DETERMINATION REPORT
Resource Recovery Facility, Moorebank (05-0157)

PLANNING ASSESSMENT COMMISSION MEETING MATERIALS RECYCLING FACILITY, MOOREBANK

Submission to Planning Assessment Commission Materials Recycling Facility, Moorebank

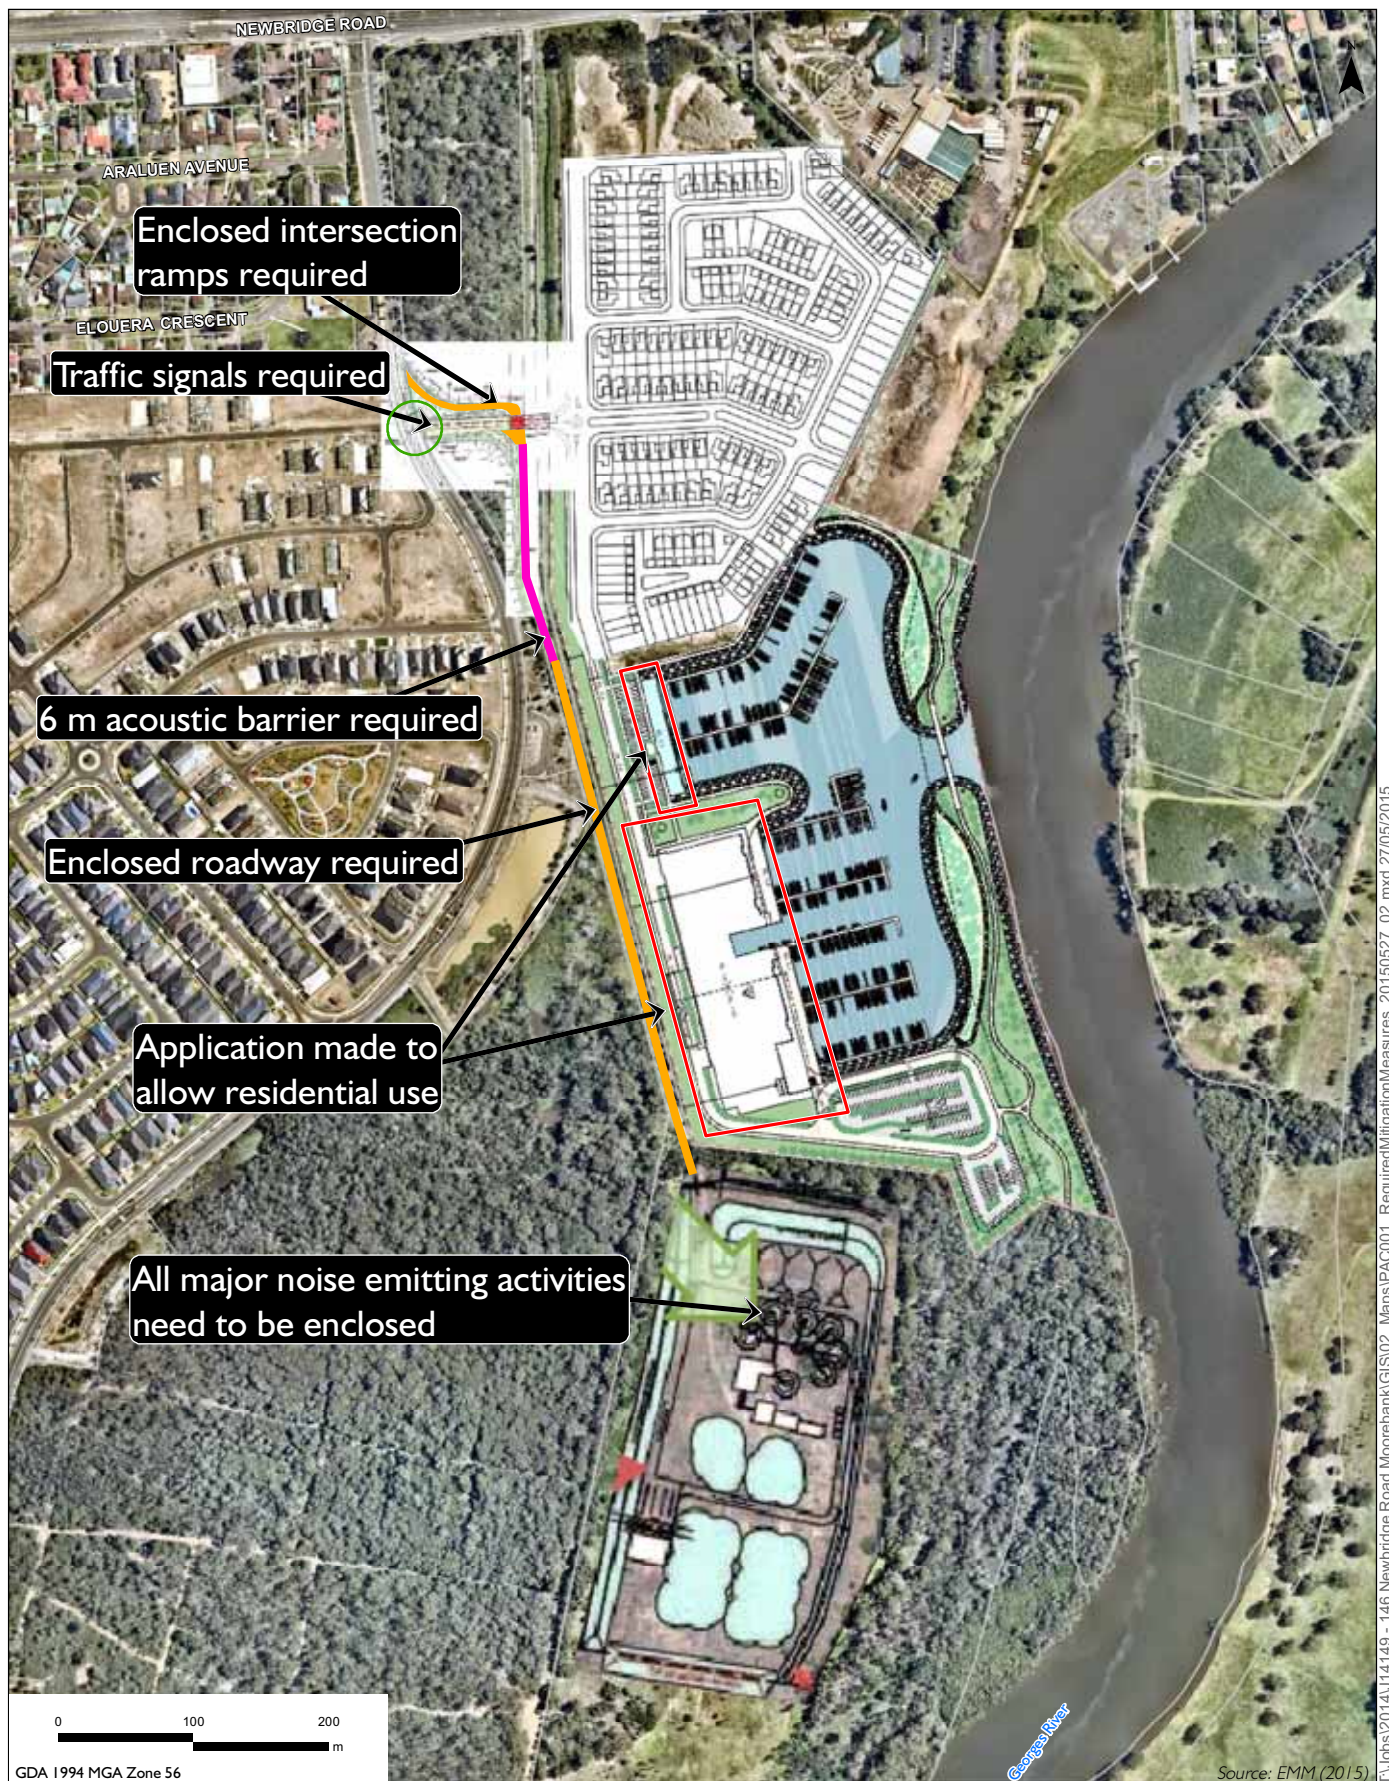
- The following noise mitigation measures would be required if there is a chance for appropriately determined noise criteria to be achieved (shown in Figure 1.1 and Figure 3.3):

The only feasible mitigation measure would be to fully enclose the site access road in the vicinity of the marina land and to fully enclose all noise generating activities within the Material Recycling Facility (see Figure 1.1).

Figure 3.1 Unattended noise monitoring locations (red) and prediction locations (blue)

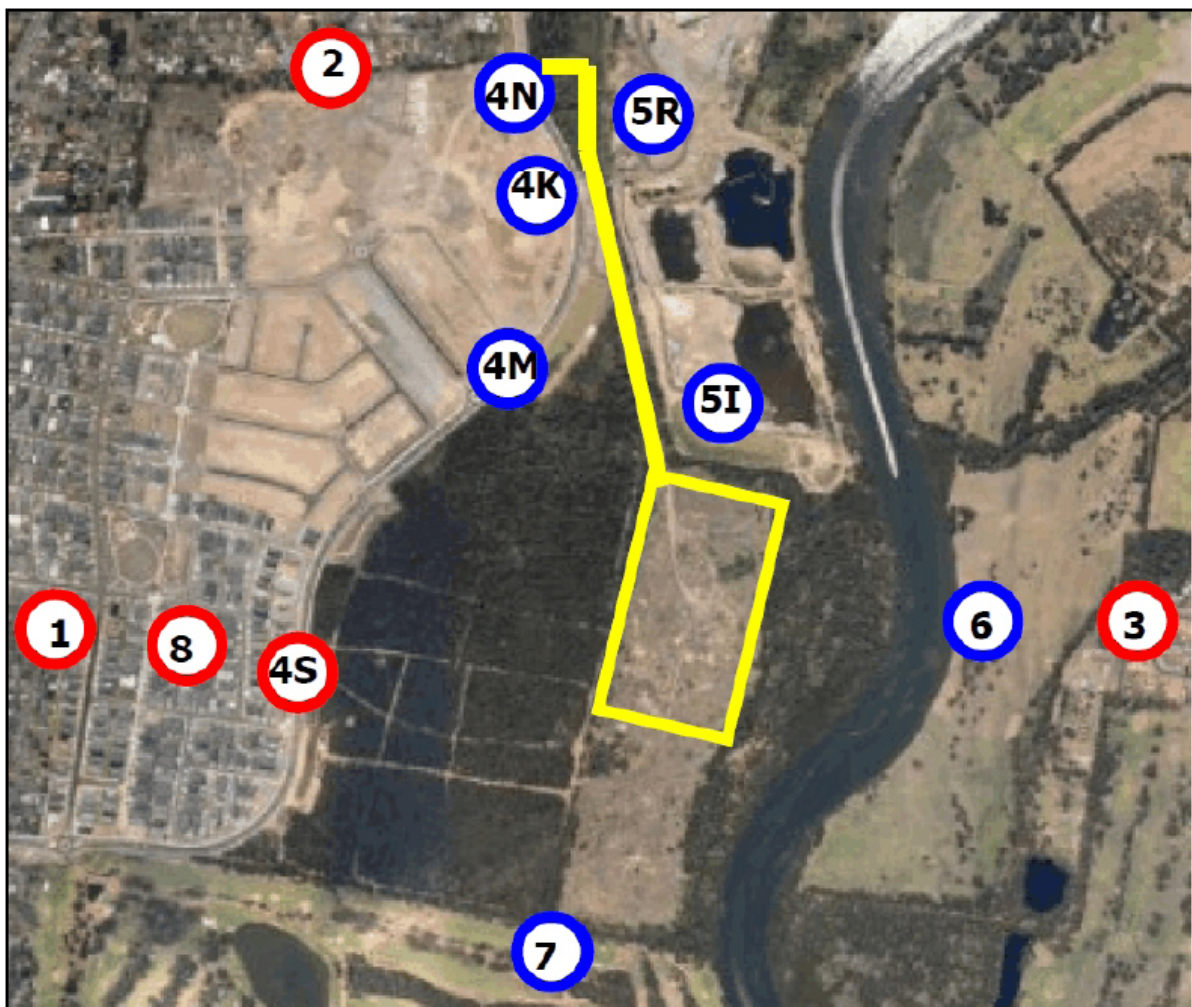
The proponent's monitoring or assessment locations are shown in Figure 3.1. Those shown in red are longer term unattended monitoring locations, while blue locations were adopted for assessment by the proponent.

- March 2007 at three locations (37 Malinya Crescent [location 1], 26 Elouera Crescent [location 2], and 41 Martin Crescent [location 3]). It is noted that 'location 1' as labelled in the proponent's figure above is incorrectly displayed and is in fact two blocks east of where it is displayed;
- May 2013 at a further three locations (16 Bushview Lane [location 4S], 81 Bradbury Street [location 8], and 28 Elouera Crescent [location 2], Moorebank); and
- October 2013 at a further single sampling location (12 Bushview Lane [location 4S], Moorebank).

Noise monitoring locations - May 2015
 Planning Assessment Commission Submission
 Materials Recycling Facility, Moorebank
 Figure 3.2

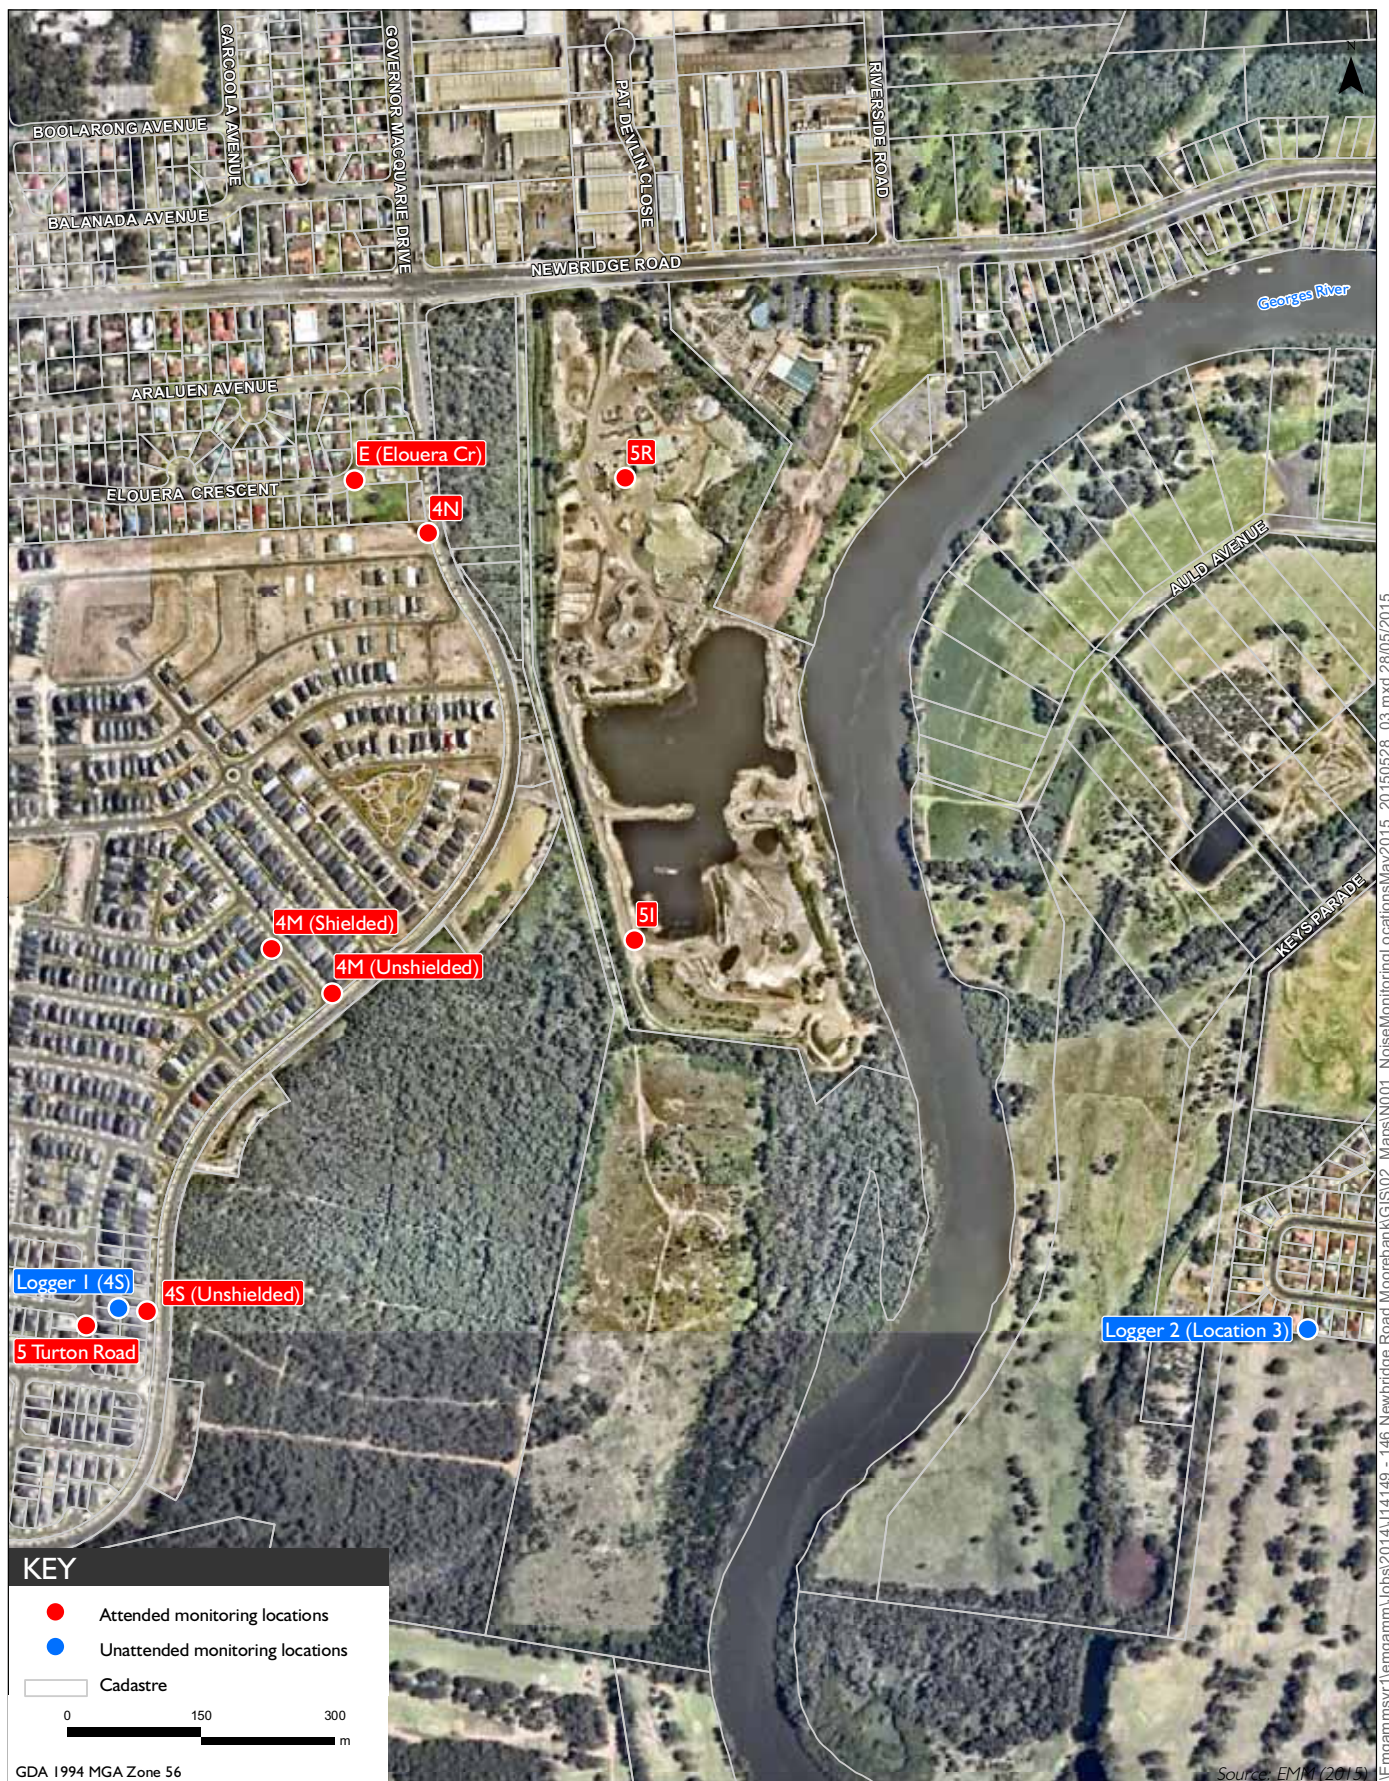
Unattended monitoring was undertaken at the following locations (refer to Figure 3.2):

The EMM logger data for 20 to 27 May 2015 (refer to Appendix A Table A.1 for daily data and charts) shows the following daytime background levels (ignoring the quieter Sunday data and INP weather exclusion rules for now until more data is collected):

- Location 4S - Georges Fair- 34 dB(A);
- Location 3 - Milperra - 39 dB(A) (ignoring Sunday made no difference).

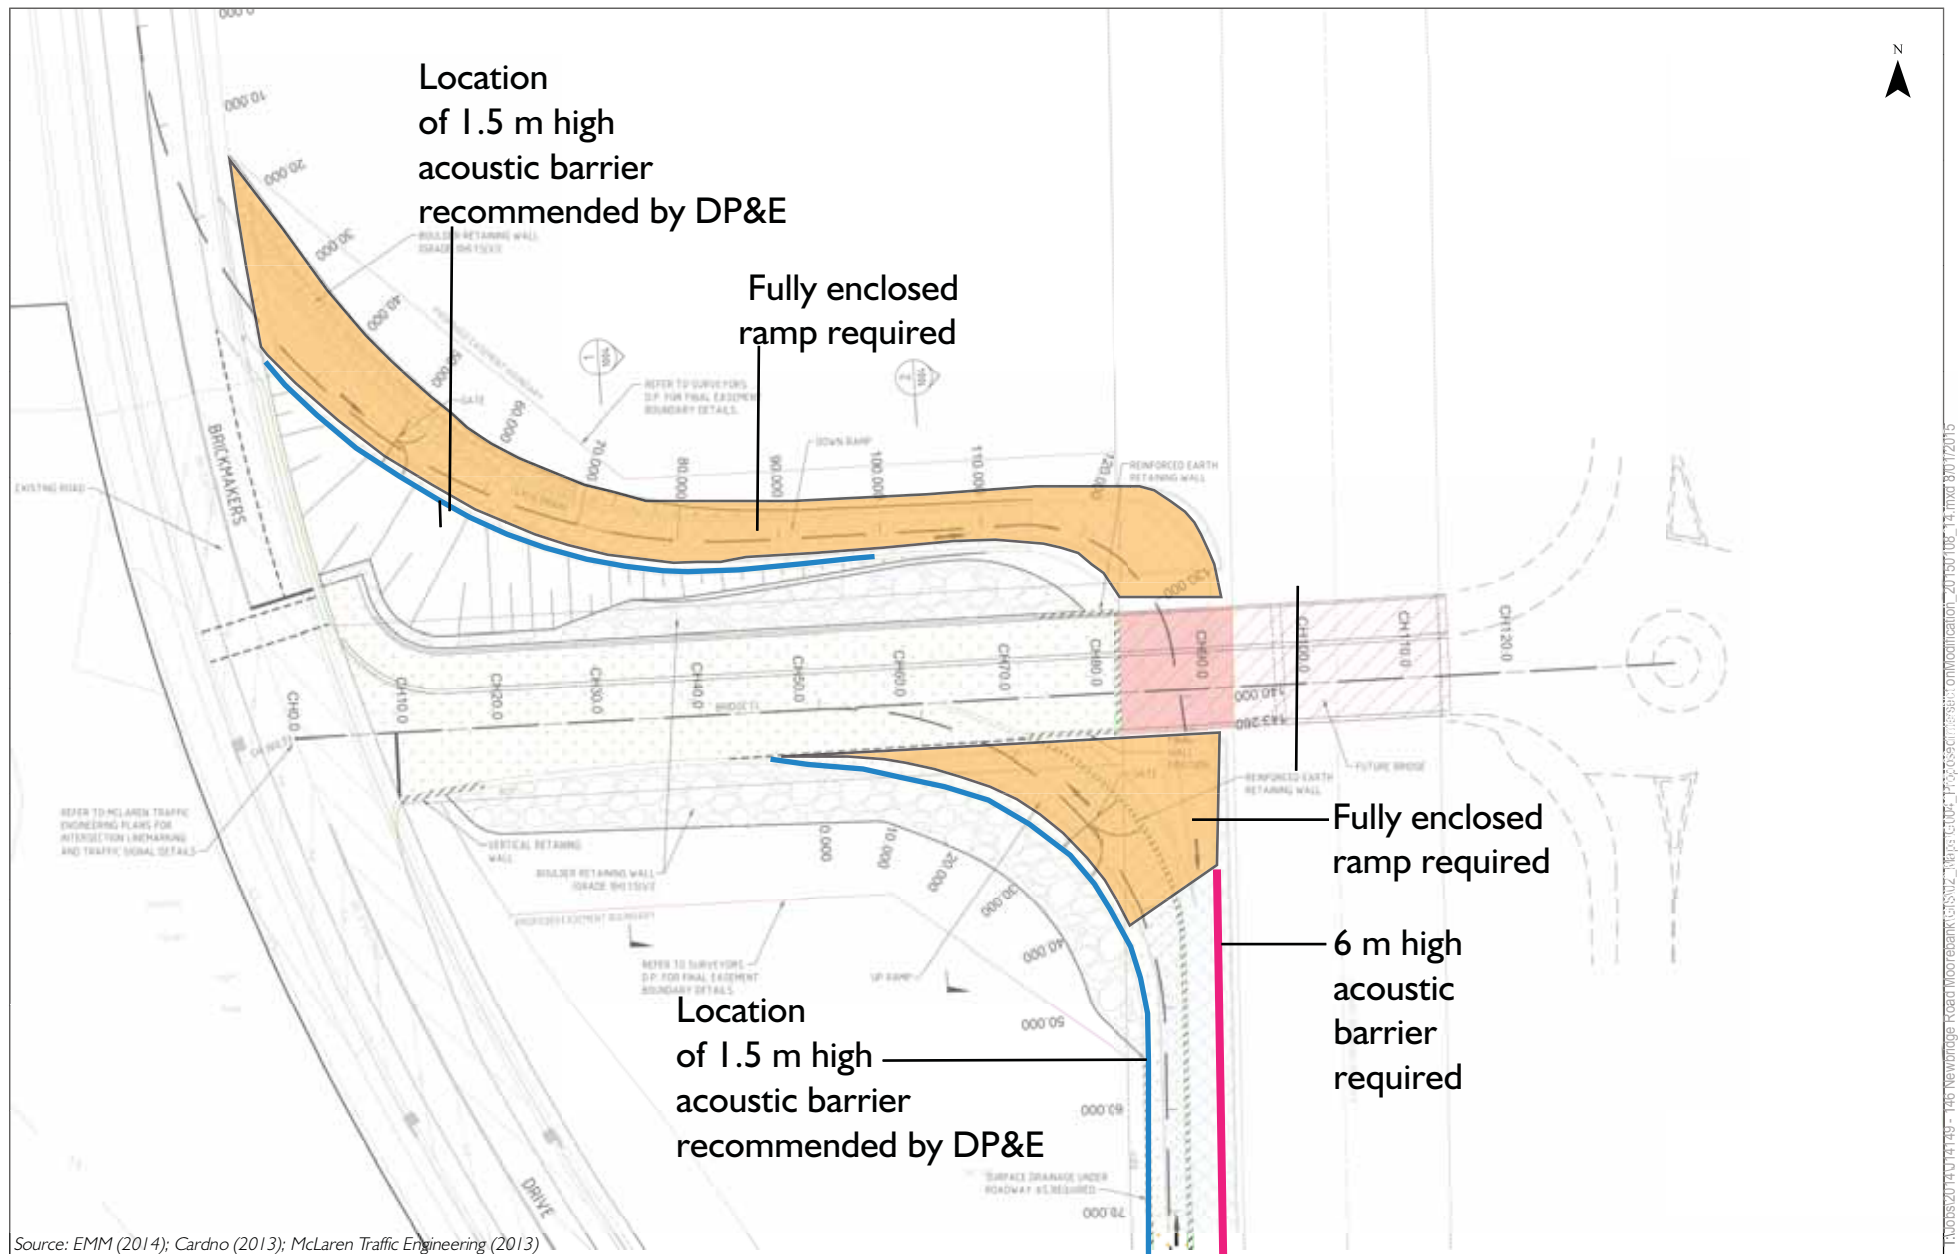
Acoustic barriers are best placed at the source, in this case immediately beside the access road. Barriers need to be considerably higher if they are constructed away from the noise source, particularly if they are also distant from the receiver. The planned residences in the immediate south of the northern portion of Benedict Industries site will be protected to a greater degree than residences further from an acoustic barrier as they will be in the immediate or 'shadow zone' of the acoustic barrier.

A 10 dB exceedance is highlighted for these residences (see Section 3.5) due to the access road and ramps to/from Brickmakers Drive. Such an exceedance is significant and for this reason, a combined barrier and enclosure of ramps as described by Dr Tonin is recommended ie 6 m high acoustic barrier on the east of the access road and enclosing of the ramps.

Note: Appendix D is to be updated to reflect the above barrier and enclosure detail (refer to Figure 1.1 and Figure 3.3).
